OPTIONAL SERVICE BULLETIN

OSB 42-130

Modification of the induction system and the charged air system.

WI-OSB 42-130

Figure 3

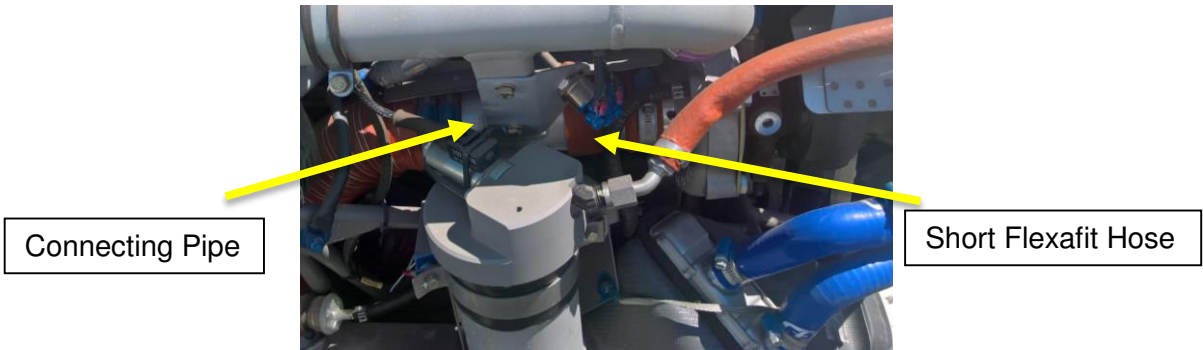
8 Open clamps and remove short Flexafit Hose, Connecting Pipe and Heat Protection Sheet.

Figure 4

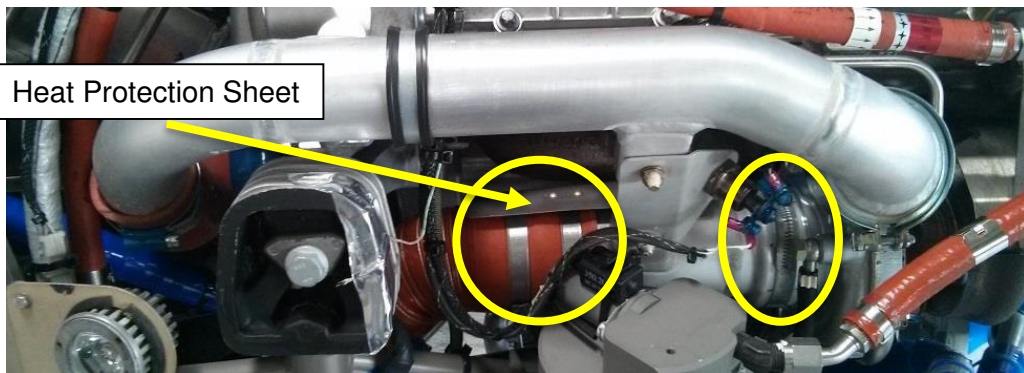
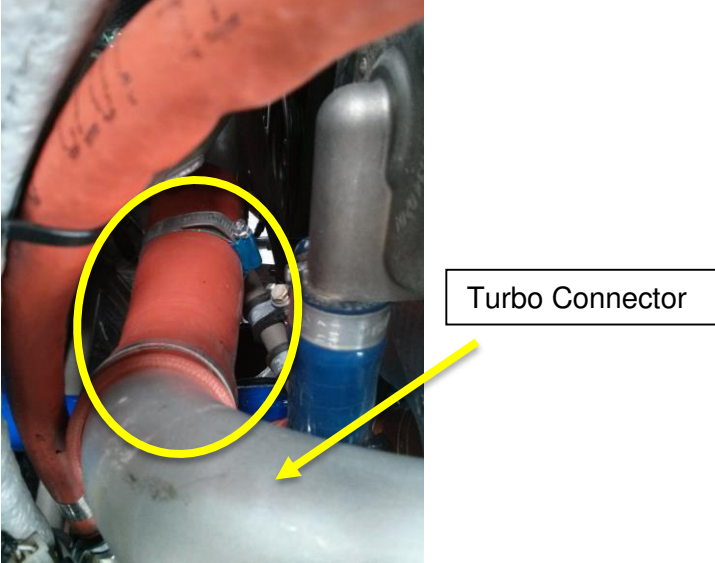
9 Install Connecting Pipe:

- Install Connecting Pipe 52-7160-H0020 02 and Heat Protection Sheet 52-7160-H0025 01
- Install Connecting Pipe on Turbo charger with Hose Clamp NM-0000-00172 01
- Install Connecting Pipe with the Heat Protection Sheet on long Flexafit with 2 Clamps NM-0000-00170 01
